R100-3 ISSUE RISK FOR AC 48V MOTOR GENERATORS

Submitted by the expert from CLEPA the European Association of Automotive Suppliers

Informal document GRSP-69-03 (69th GRSP, 17-21 May 2021 agenda item 23(g))

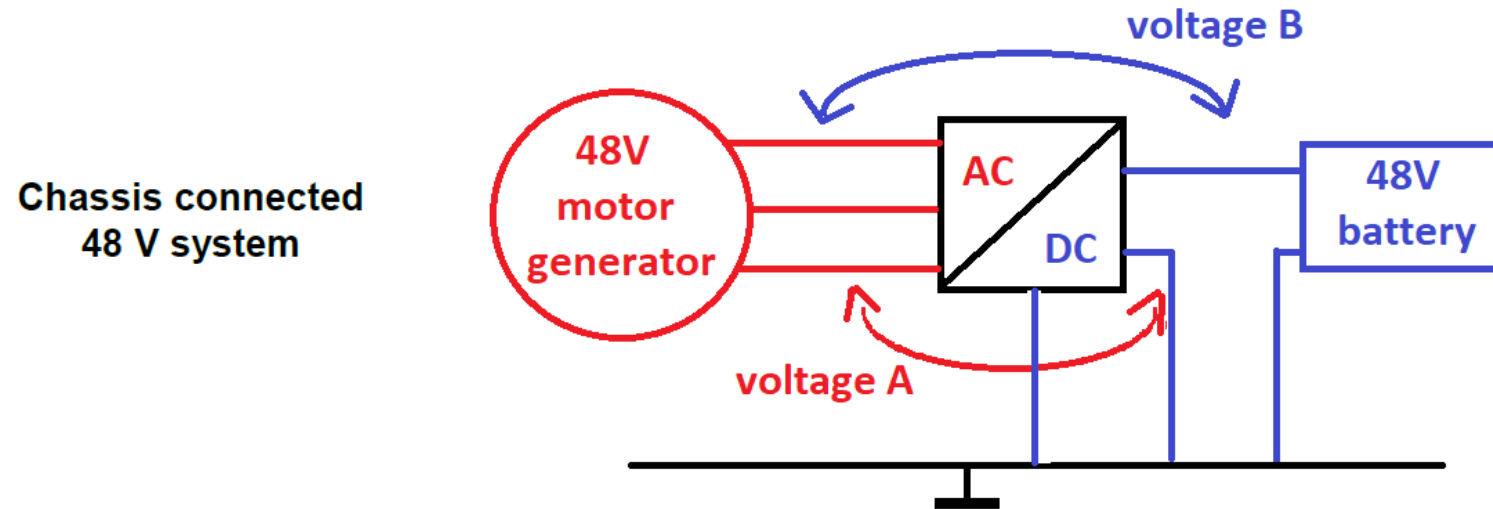
- Current version of the introduction of the “specific voltage condition” in ECE-TRANS-WP.29-GRSP-2020-06e, chapter 2.42 can be a risk for especially 48V air cooled components like e.g. 48V motor generators which are sold from various suppliers and are in series since years with different OEMs.

- Although this was not intended (according to discussions with experts from e.g. OICA), the currently proposed text of paragraph 2.42 48V air cooled components can be interpreted in a way that it do not fulfil the “specific voltage condition” even if it is connected to chassis ground. The reason is, that it is not clear if the voltages between “a DC life part and an AC life part” have to be interpreted as a composite voltage or ‘pure’ AC voltage. Especially the use case, which is possible according to the current text of paragraph 2.42 has not been considered and evaluated sufficiently: “AC condition between a DC life part and an AC life part” (e.g. the B+ bolt of a 48V motor generator to a phase of the same device). If the voltage is a composite/mixed signal, it is > 30 V AC (rms) and the “specific voltage condition” is not fulfilled.

- If the “specific voltage condition” is not fulfilled the new “water isolation resistance test” applies. Air cooled 48V Motor Generators are expected not to pass this test.

- CLEPA proposes to add a 2nd footnote to paragraph 2.42 regarding the (correct) interpretation of composite voltages, to avoid any mis-interpretation.

Detailed Explanation of Voltages A / B

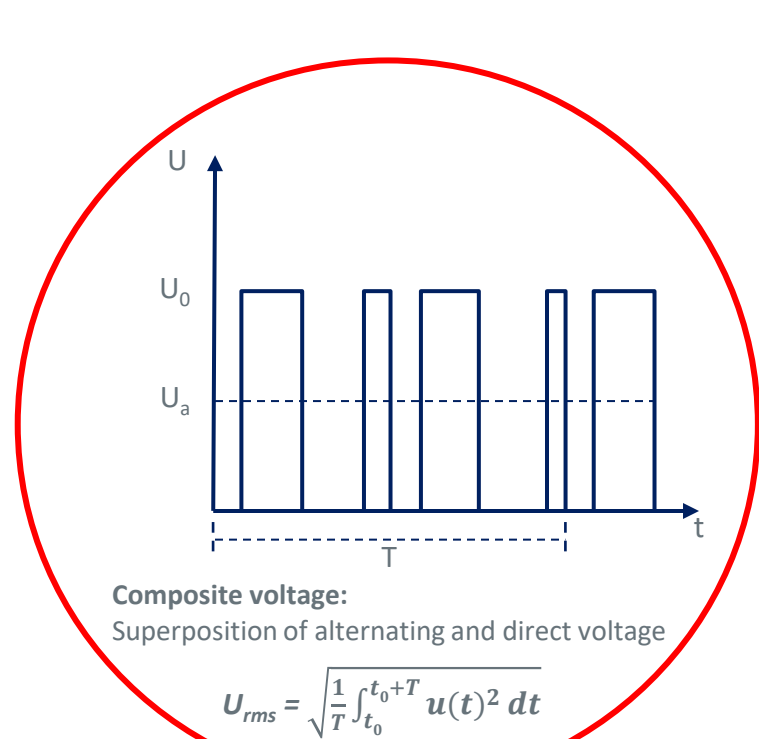
Explanation of Voltages A / B using a 3 phase example looking at one representative point P1. This valid also for other phase numbers.

T3 open, T4 closed
 → P1 is connected directly to ground
 → Voltage A = Ground
 → Voltage B = B+

T3 closed, T4 open
 → P1 is connected directly to B+
 → Voltage A = B+
 → Voltage B = Ground

T3 open, T4 open
 → Parallel circuit
 → $\text{Ground} \leq U_{P3-P2} \leq B+$
 → $\text{Voltage A/B}_{\text{max}} = U_{P3-P2}$
 if symmetric $\text{Voltage A/B}_{\text{max}} = 0.5 * U_{P3-P2}$

Voltages A and B are pulsating / switched DC voltages with $U_0 \leq B+ \leq 60V$

Composite, AC & DC Voltages in 48V Systems

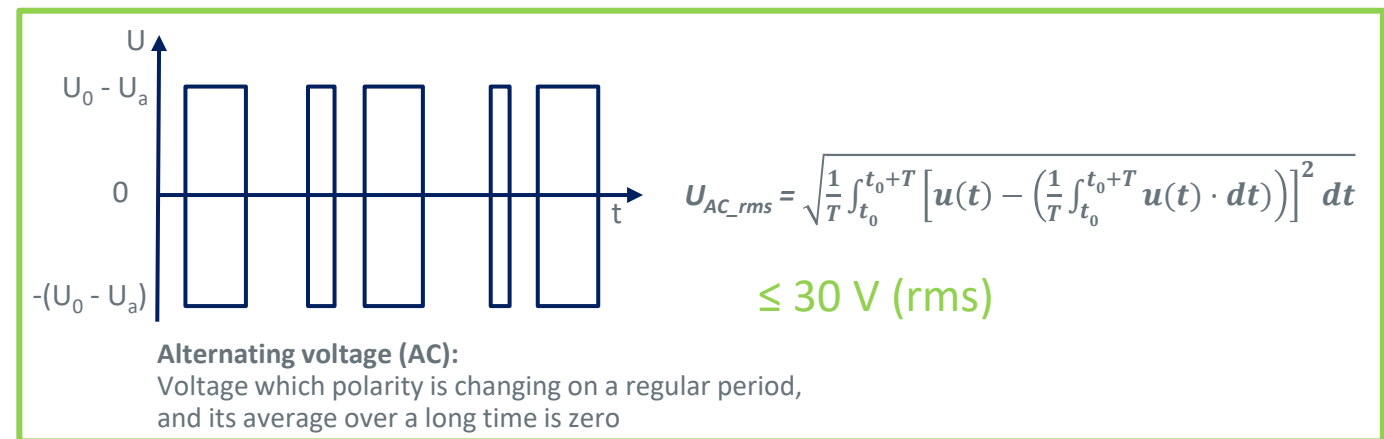
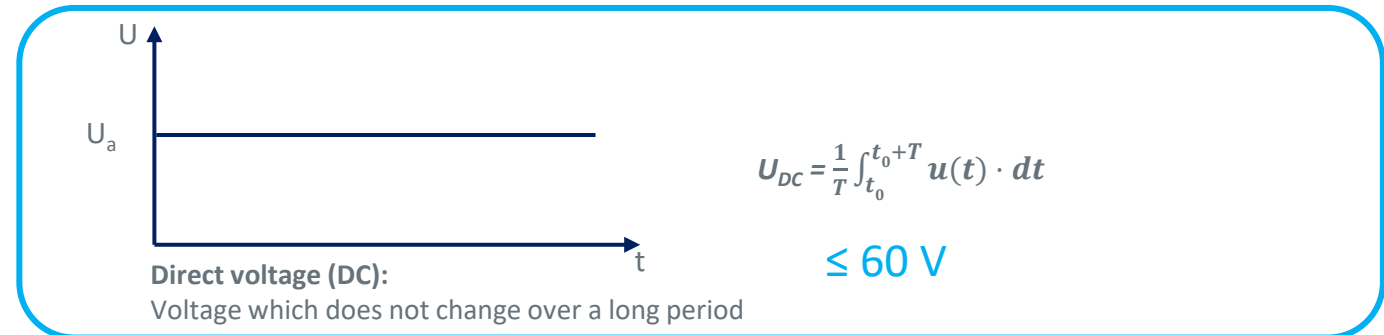
- **Key issue: Interpretation of the “red signal”:**
 - Composite AC would be a problem
 - Pure AC with DC offset evaluated separately (blue/green) OR pulsating (switched) DC with DC threshold

can be $\geq 30V \leq 60 V$ (rms)
